**RESPONSE TO ASSESSMENT MANAGER'S INFORMATION REQUEST
DEVELOPMENT ASSESSMENT RULES 2017 PART 3 S13
DEVELOPMENT APPLICATION FOR A DEVELOPMENT PERMIT FOR A
MATERIAL CHANGE OF USE FOR AN INDUSTRY DEVELOPMENT AT
167-191 CHRISTENSEN ROAD SOUTH, STAPYLTON
(LOT 304 SP329491)**

PROPOSED INDUSTRIAL BUILDINGS

LOT 304 CHRISTENSEN ROAD, STAPYLTON, QLD, 4207

SITE PLAN

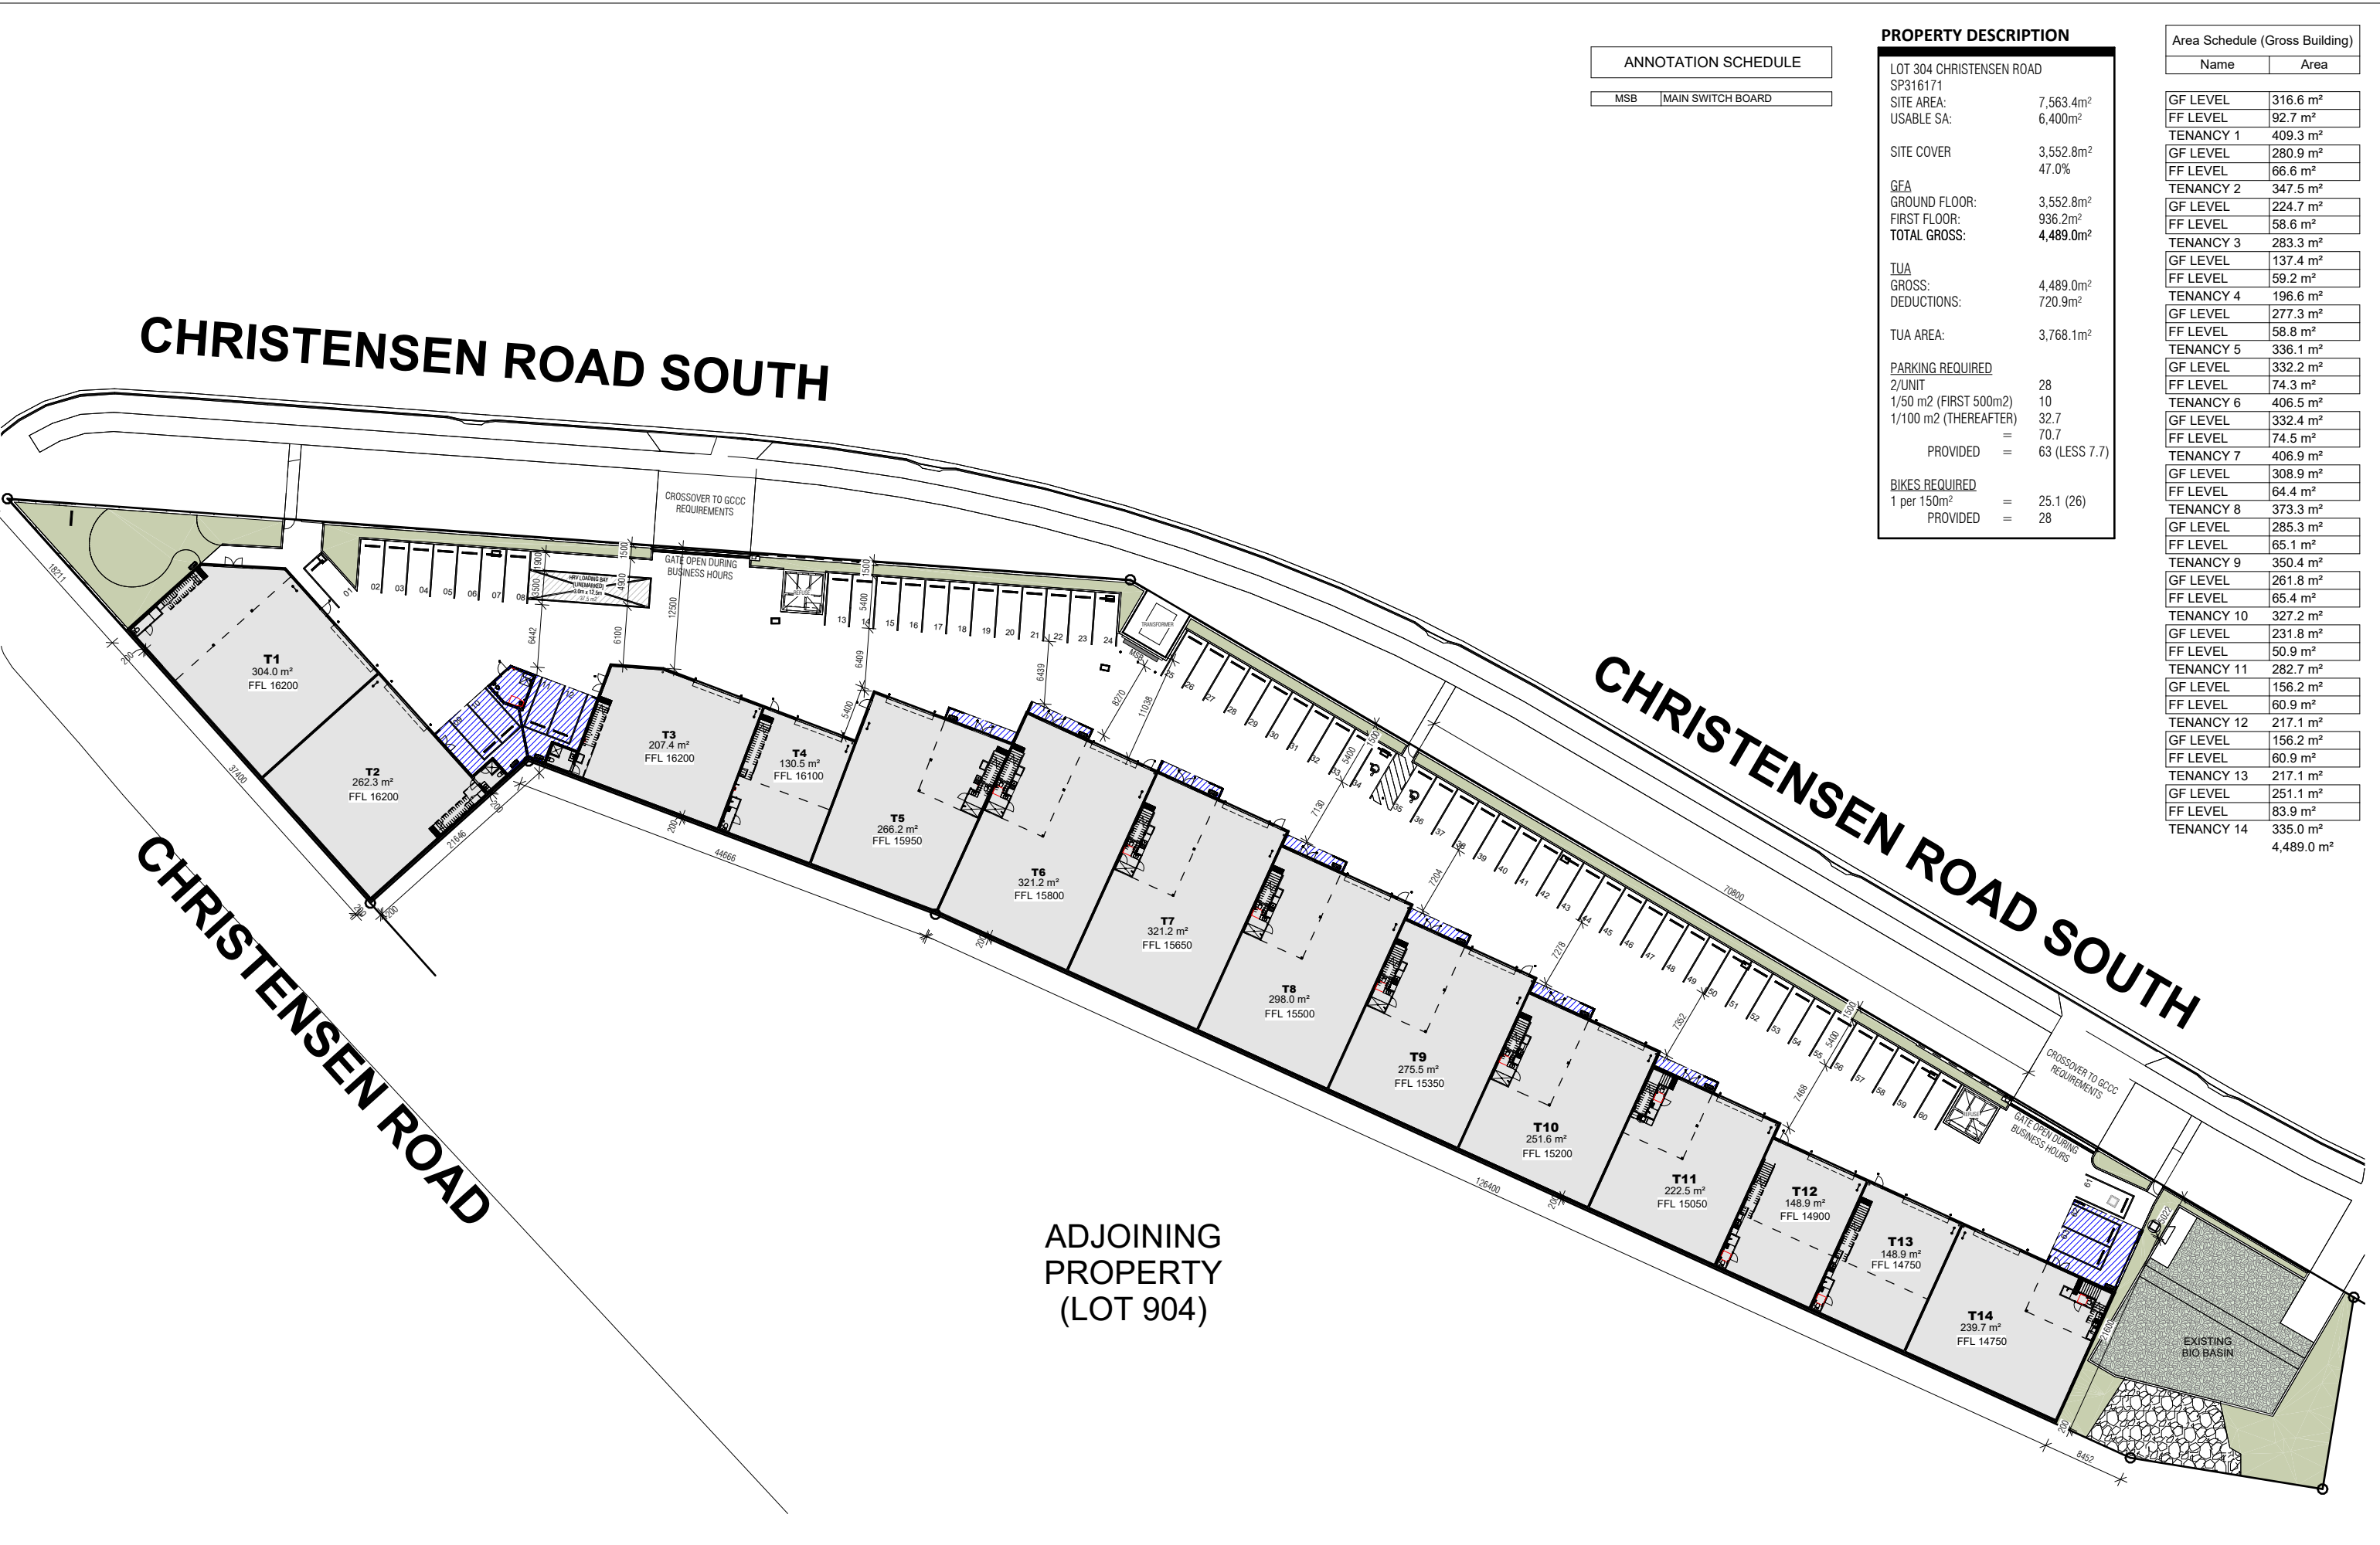
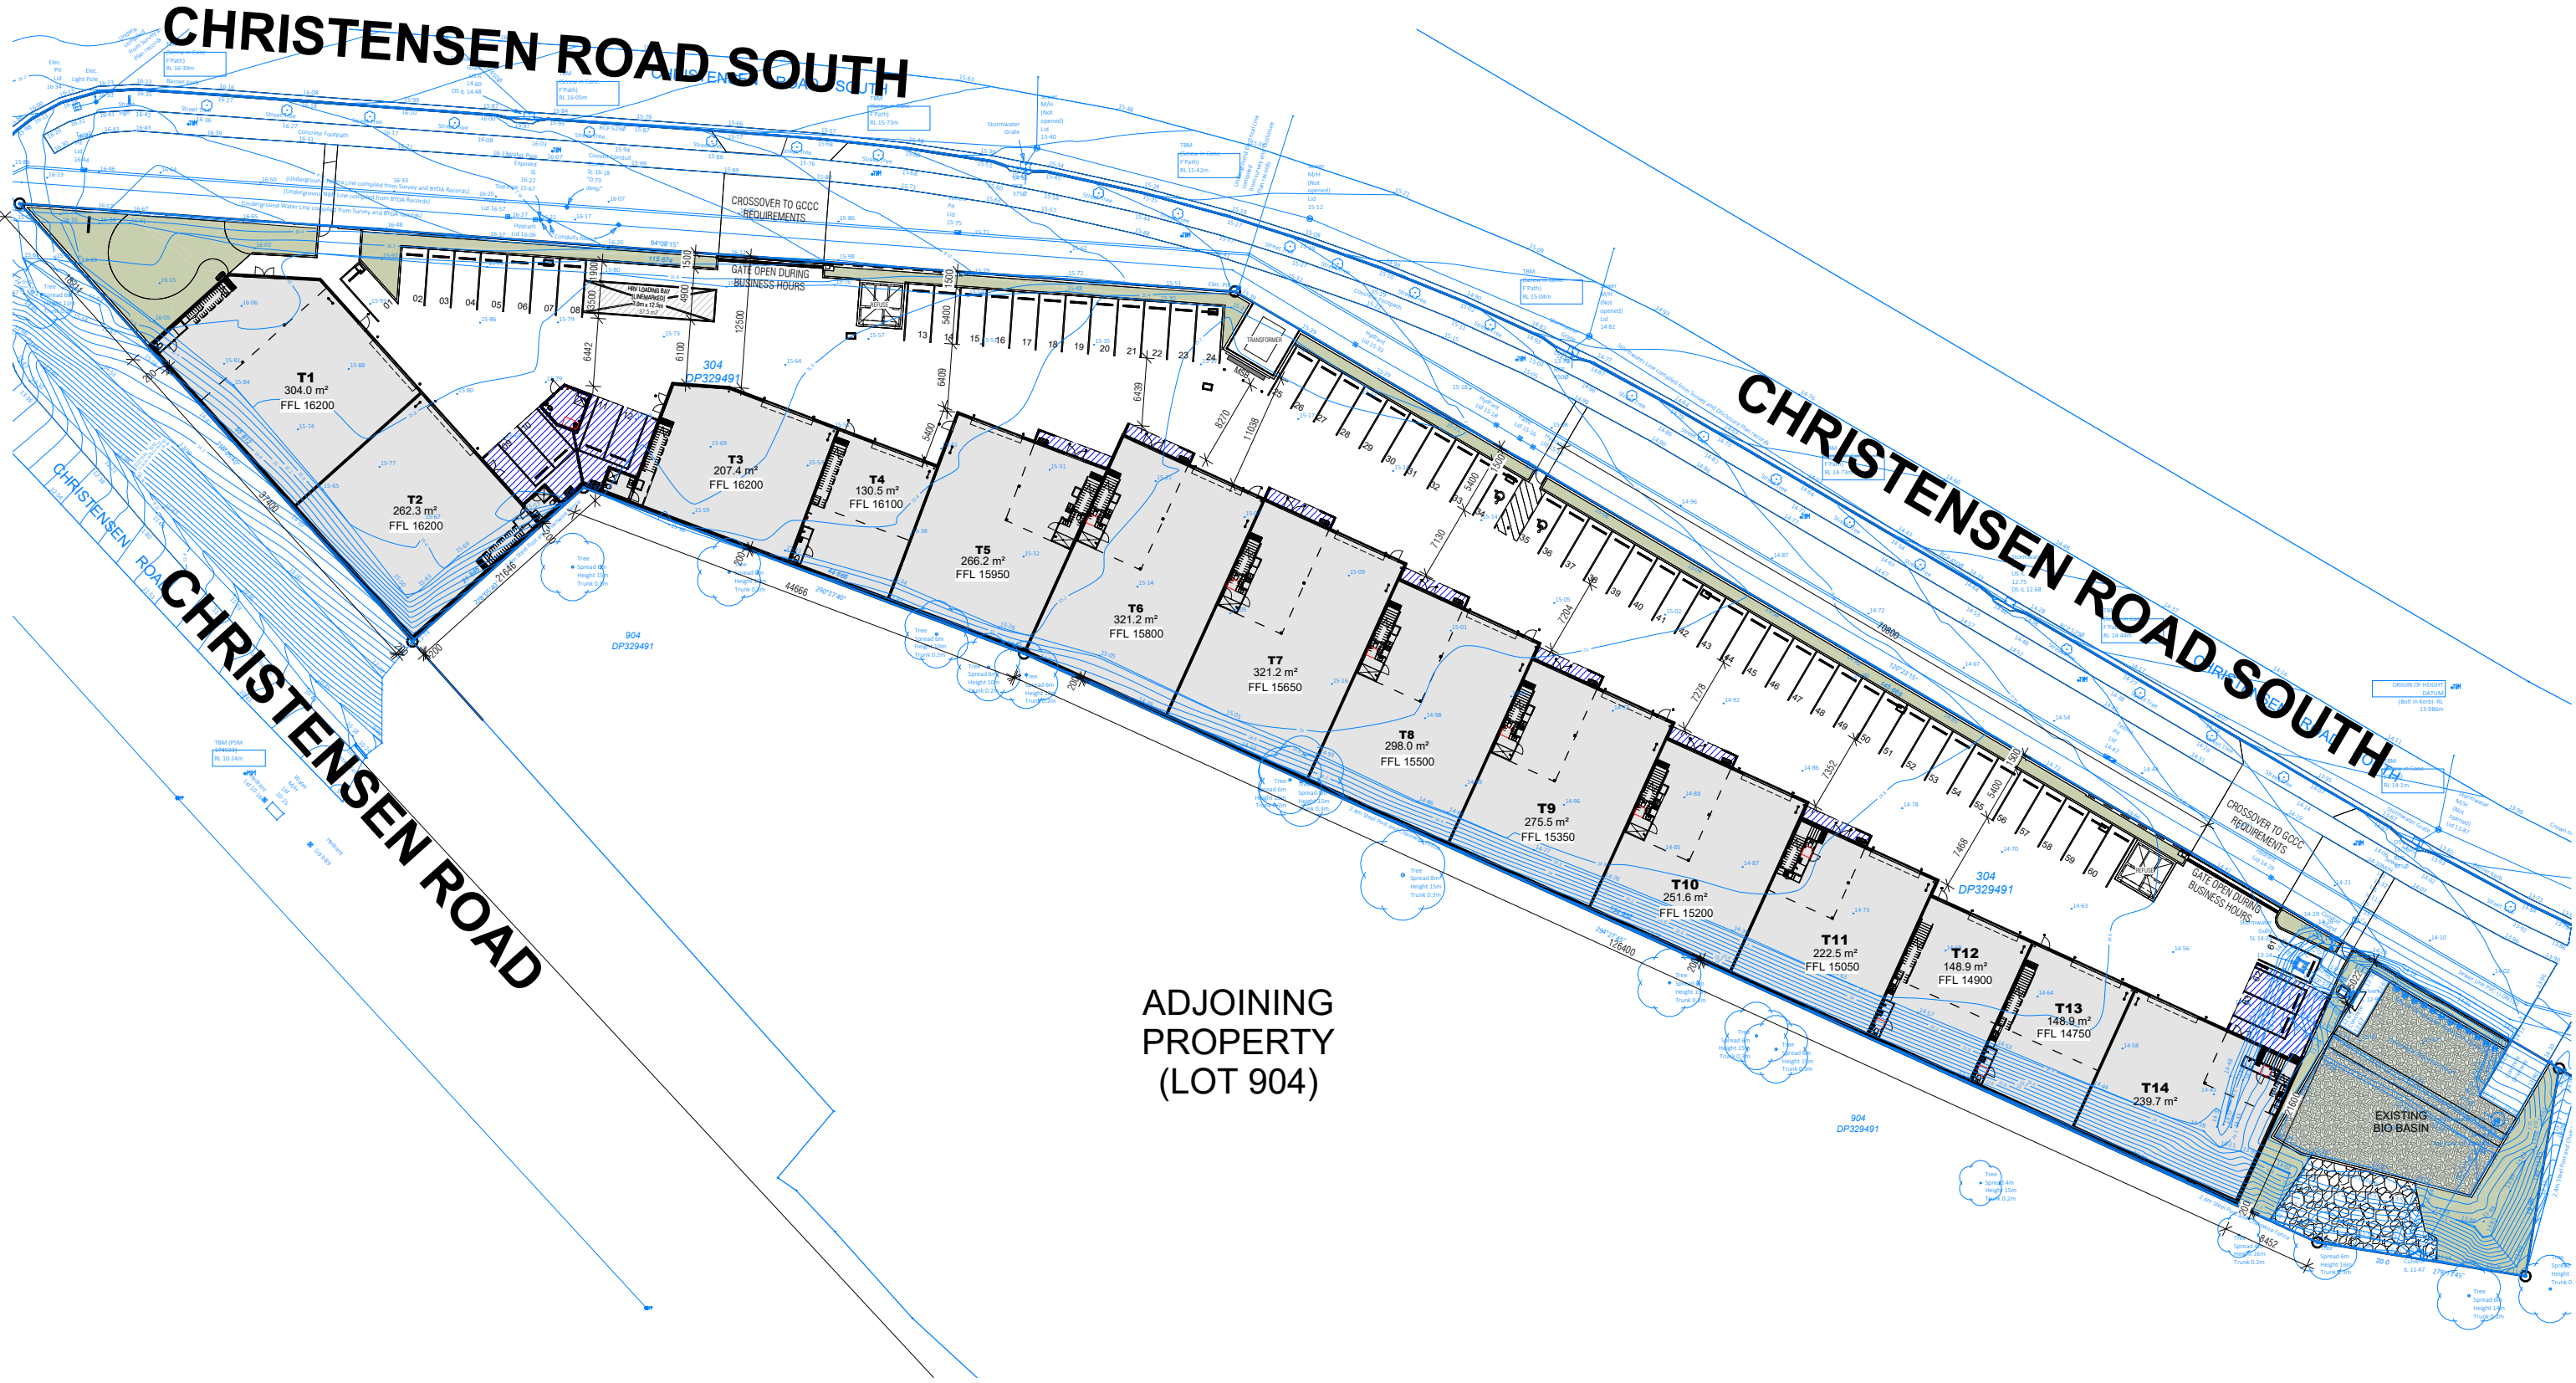
Condition 10 of COM/2023/82 requires a landscape buffer width of 1.5m and an average of 3m along the frontage of the subject site. Proposed car park lengths are only 4.9m as opposed to standard length of 5.4m. As such parked cars will overhang into the front 1.5m garden bed severely constraining the ability to successfully establish plants within the proposed garden beds. It is requested that the applicant amend the car park lengths to 5.4m and introduce wheel stops so that compliance with Condition 10 can be achieved.

- a. Provide fully dimensioned car parking spaces in accordance with AS2890.1 requirements.*

The carparking spaces have been amended to reflect a minimum length of 5.4m with no overhang to the frontage landscape buffer. The resulting outcome is that the frontage landscape buffer achieves a minimum width of 1.5m and is suitable for successfully establishing plants and trees.

The revised carparking bays as discussed within the response to Item 5 above have been amended to reflect a minimum length of 5.4m with no vehicle overhang. All carparks have been dimensioned within the revised proposal plans (**Attachment 2**).

1 OVERALL CARPARK SETOUT PLAN
1 : 300

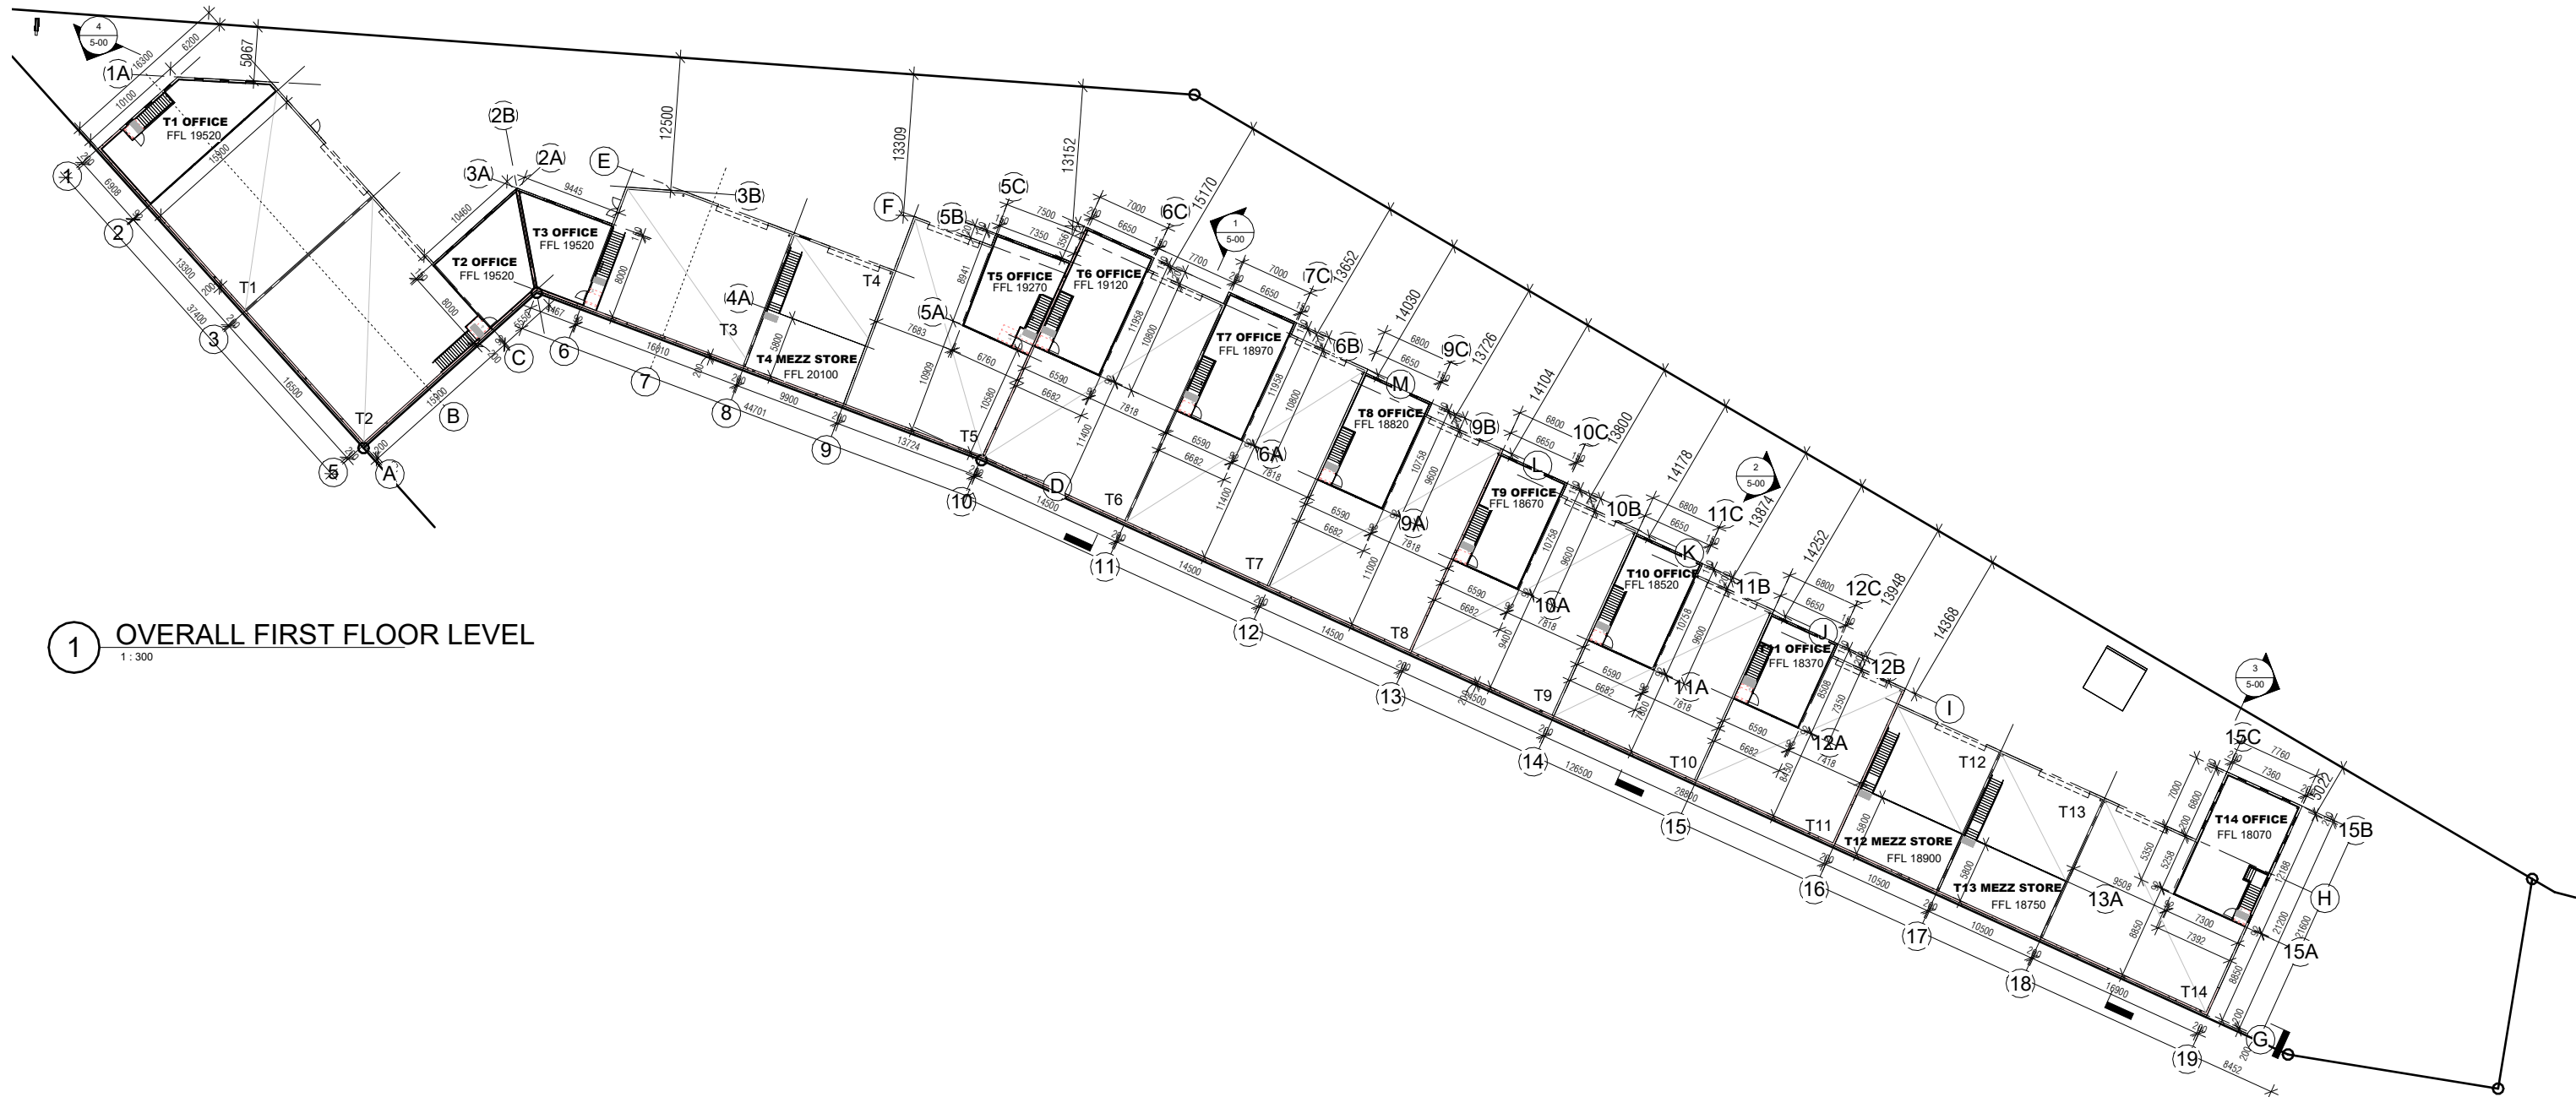
- a. Amend the proposal to provide a minimum of 72 compliant on-site car parking spaces in accordance with AS8.1.2; or*
- b. Submit a robust performance-based assessment addressing PC8 of the M38 Industrial Estate Place Code. Any such assessment must include:*
 - i. Identification of the intended or likely future users and the types of industrial land uses anticipated to occupy the tenancies.*
 - ii. An evaluation of the anticipated number of staff per tenancy and the overall peak staff generation for the site.*
 - iii. An assessment of expected visitor parking demand associated with the proposed industrial uses.*

With consideration to a revised design now incorporating a maximum of 14-tenancies, the proposal provides a total of 63 car parking spaces, resulting in a shortfall of eight spaces across the 14-tenancy development. The site benefits from approximately 260m of frontage to Christensen Road South, which is capable of accommodating on-street parking along its length.
